# Georgia Institute of Technology

## MEMORANDUM

Subject: facility high radiation areas

SECOND FLOOR

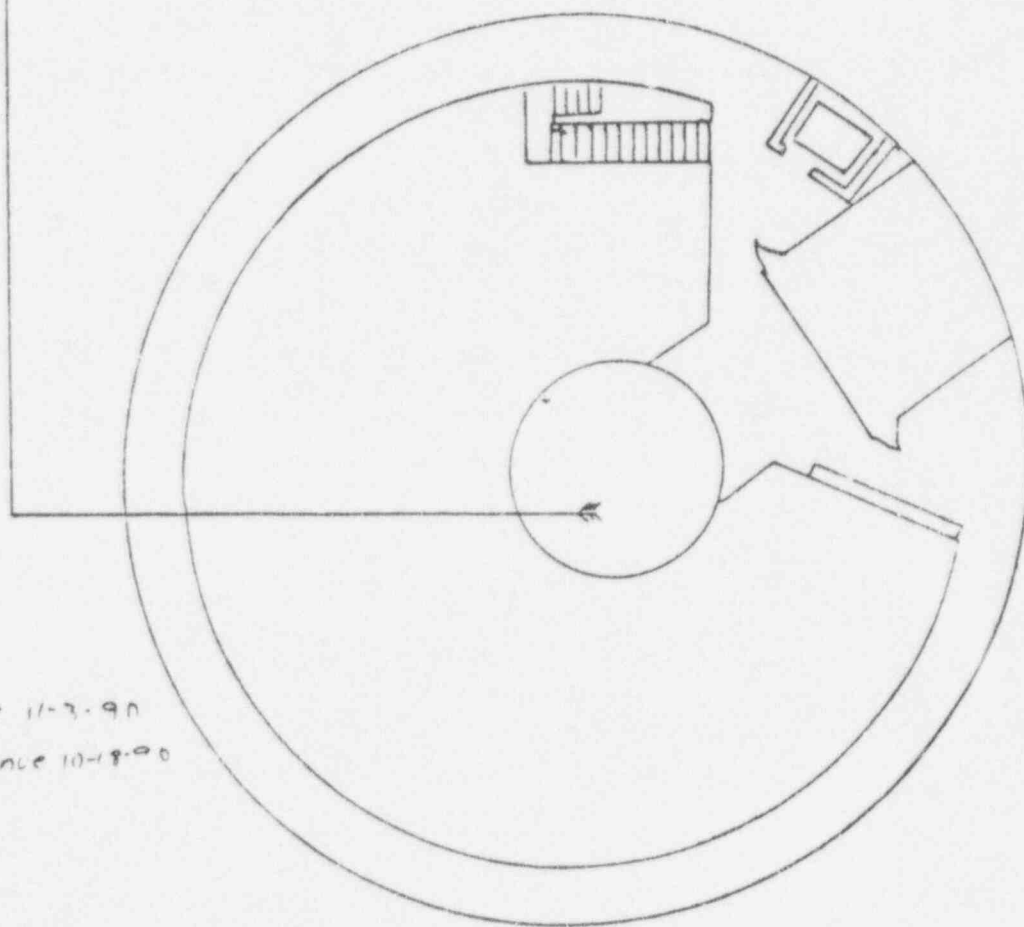
1. reactor top
2. biomedical facility on first floor
3. outside of process equipment room door on ground floor
4. niche under biomedical room beam port on ground floor

In the case of the reactor top, direct surveillance by an operator is always in place whenever the reactor is at power. However, the area must still be posted as "Caution, High Rad. Area" and "dosimetry required for entry".

FIRST FLOOR

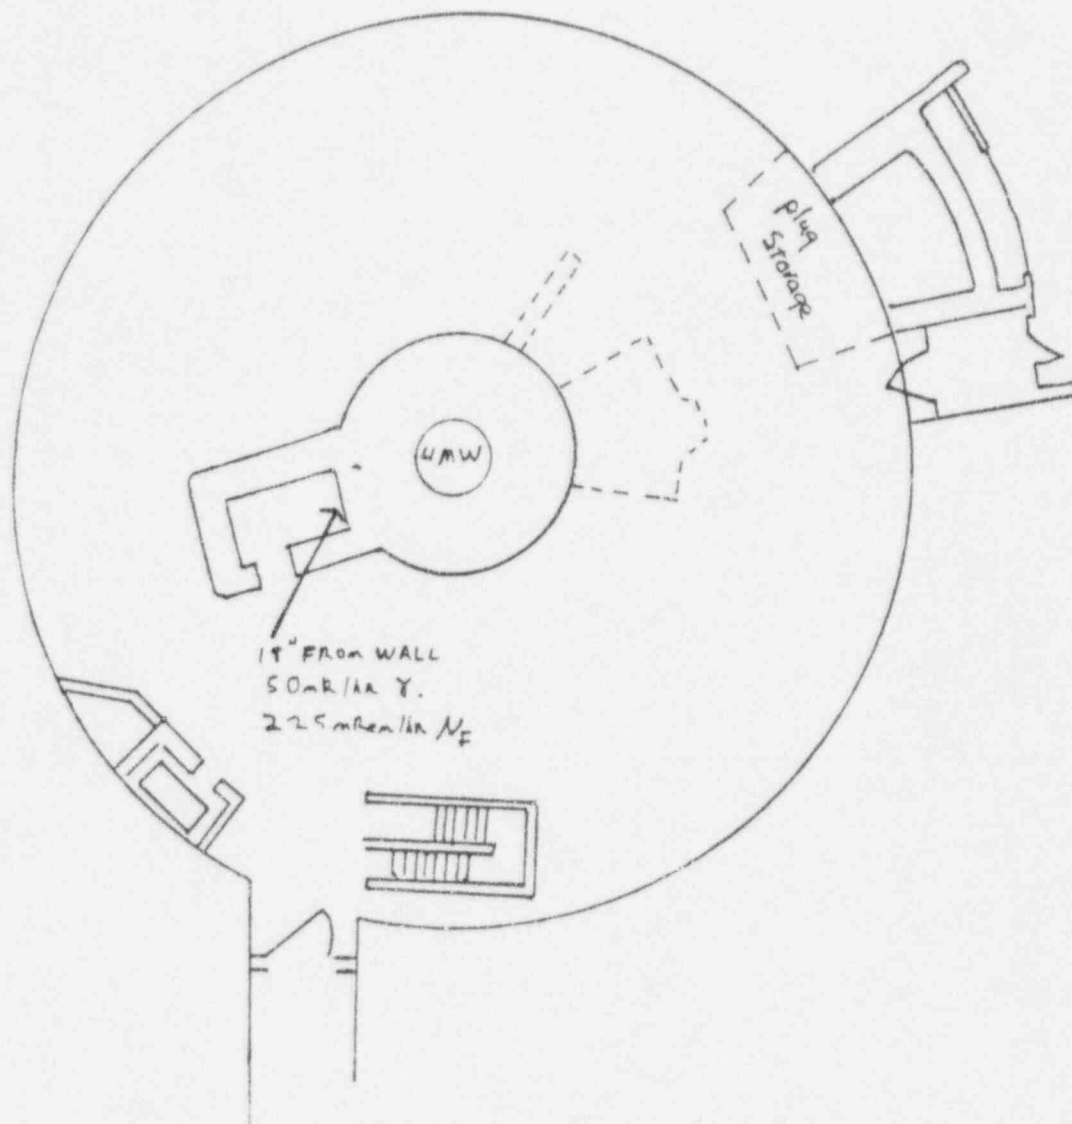
The biomedical facility must be similarly posted and have access controlled by either of methods 1 (locking) or 3 (alarm) above. I would suggest that the simplest choice is to install a locking gate on the facility door.

GROUND FLOOR

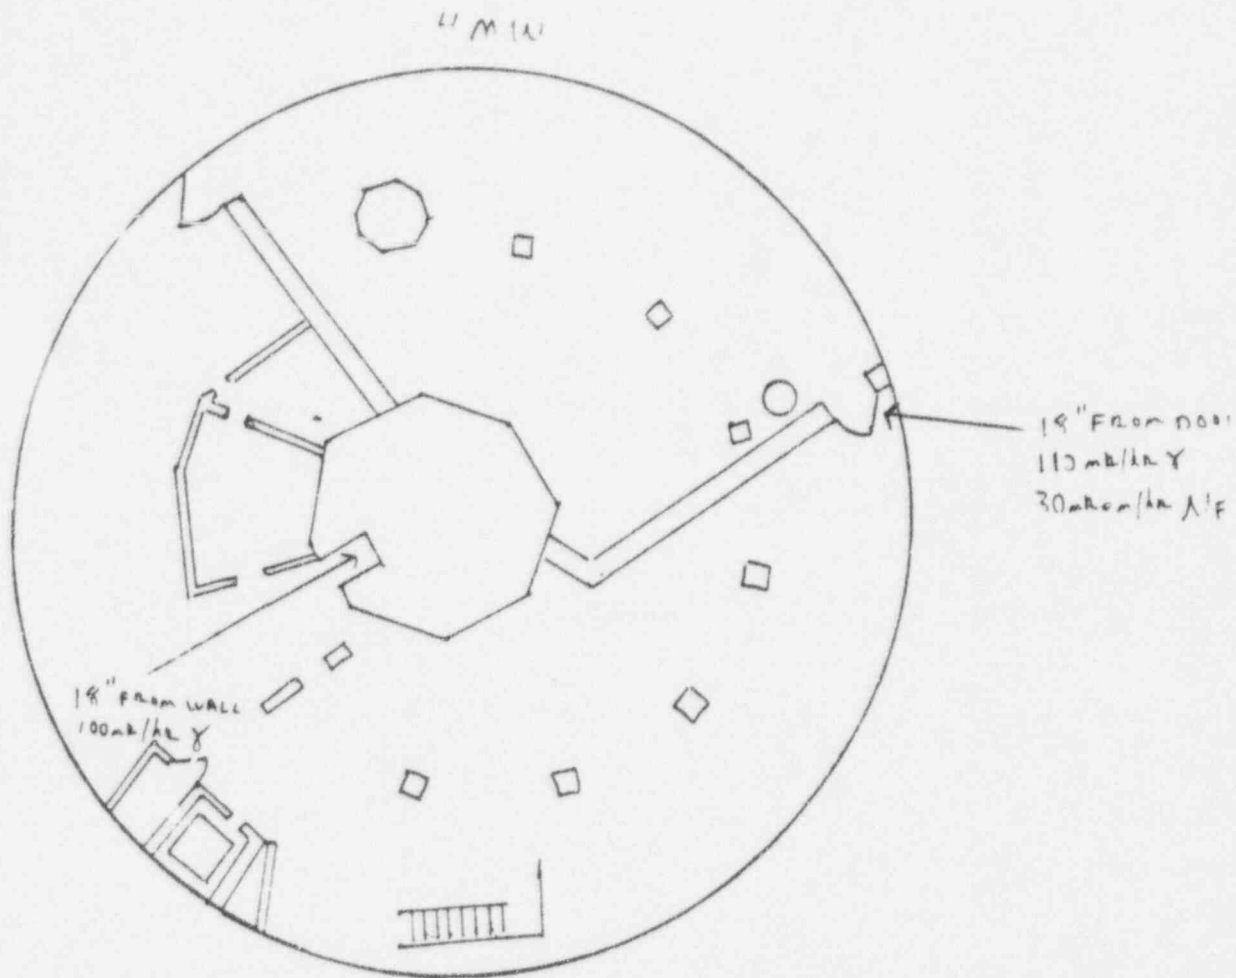
The area below the biomedical facility on the ground floor is currently considered a contaminated area due to beamport cooling water leakage from above. I believe that constructing a simple locked enclosure around this area would solve both the problems of contamination control and access to the high radiation area. Posting the area is also required.

The area near the process equipment room door is very localized and it may be possible to reduce radiation levels by installation of further shielding in the door or around nearby equipment.
